Project	<b>IEEE 802.16 Broadband Wireless Access Working Group &lt;<a href="http://ieee802.org/16">http://ieee802.org/16</a>&gt;</b>	
Title	<b>Space-frequency bit-interleaved coded modulation for MIMO-OFDM/OFDMA systems</b>	
Date Submitted	<b>2004-11-17</b>	
Source(s)	Sumeet Sandhu, Nageen Himayat, Shilpa Talwar, David Cheung, Qinghua Li <b>Intel Corporation</b>	sumeet.sandhu@intel.com Voice: +1-408-765-8558

# Space-frequency bit-interleaved coded modulation for MIMO

### 8.4.8.10 Space-frequency bit-interleaved coded modulation (SF-BICM)

Figure 1: Space-frequency bit-interleaved coded modulation (SF-BICM)

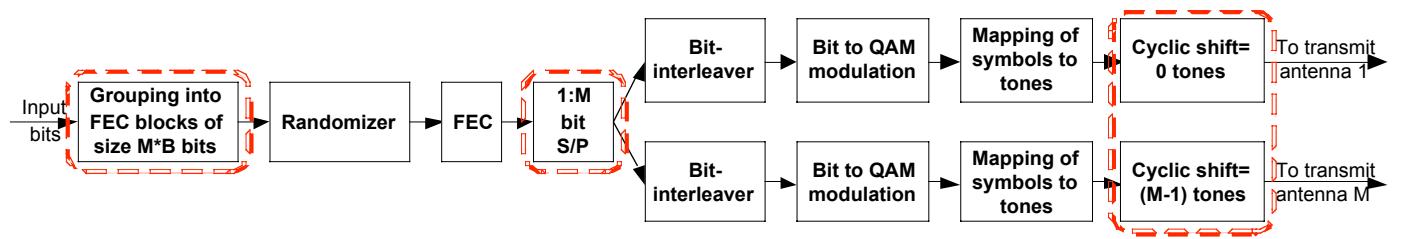
This section describes 4 steps for mapping bits to multiple spatial streams and tones. The key changes are steps 1, 2 and 4, and are circled in red in the figure below.

- 1) **FEC encoding:** The incoming uncoded bits are grouped into blocks of size  $MB$  and encoded with the usual convolutional code and punctured. The coded output blocks are of size  $MN_{CBPS}$ .

- 2) **Serial to parallel multiplexing:** The FEC block is multiplexed to different spatial streams. The bits indexed by  $m:M:MN_{CBPS}$  are mapped to the  $m^{\text{th}}$  spatial stream for  $m=1, \dots, M$ .
- 3) **802.16e interleaving and tone mapping:** The resulting groups of  $N_{CBPS}$  bits on each spatial stream are interleaved according to the 802.16e interleaver and Gray mapped to QAM symbols. The resulting QAM symbols are mapped to  $N_{DS}$  tones according to 802.16e sub-channelization and tone-mapping. The same set of tones is occupied on each spatial stream.
- 4) **Cyclic tone shift:** The final step consists of cyclically shifting the symbol sequence mapped to the  $m^{\text{th}}$  spatial stream by  $m-1$  tones to the right.

Figure 3: Proposed SF-BICM mapping of bits to multiple antennas (or spatial streams)

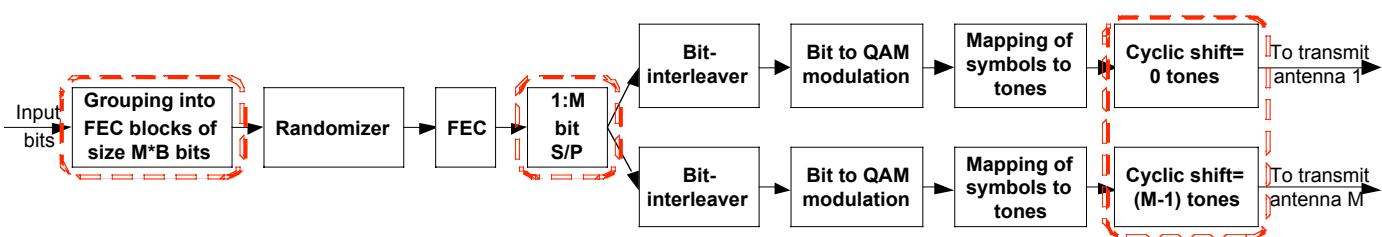
The proposed modifications to the existing 802.16e bit-to-tone mapping are steps 1, 2 and 4 as circled in red below.

- 1) **FEC encoding:** Group the incoming uncoded bits into blocks of size  $MB$ , such that the coded output blocks are of size  $MN_{CBPS}$ . It is important to create larger FEC blocks to preserve frequency diversity

going from SISO to MIMO systems. If the FEC block size were held constant and  $N_{CBPS}$  bits were mapped to  $I/M$  of the SISO tones on  $M$  antennas, spreading across fewer tones on each antenna will not provide full frequency diversity.

- 2) **Serial to parallel antenna multiplexing:** Coded bits are serial to parallel multiplexed to different antennas. The bits indexed by  $m:M:MN_{CBPS}$  are mapped to the  $m^{\text{th}}$  antenna.

- 3) **802.16e interleaving, modulation and tone mapping:** The resulting groups of  $N_{CBPS}$  bits on each antenna are interleaved according to the 802.16e interleaver and Gray mapped to QAM symbols. The resulting QAM symbols are mapped to tones in the assigned 802.16e sub-channels.

- 4) **Cyclic tone shift:** The final step consists of introducing a cyclic shift of  $m-1$  tones to the symbol sequence mapped to the  $m^{\text{th}}$  antenna. This ensures that adjacent coded bits aren't mapped to the same tone on different antennas. If adjacent coded bits get mapped to the same tone on different antennas, an MMSE receiver correlates the noise on all these bits thus degrading performance. Placing adjacent coded bits on different tones on different antennas de-correlates noise on adjacent bits, thus improving performance and providing greater spatial diversity.
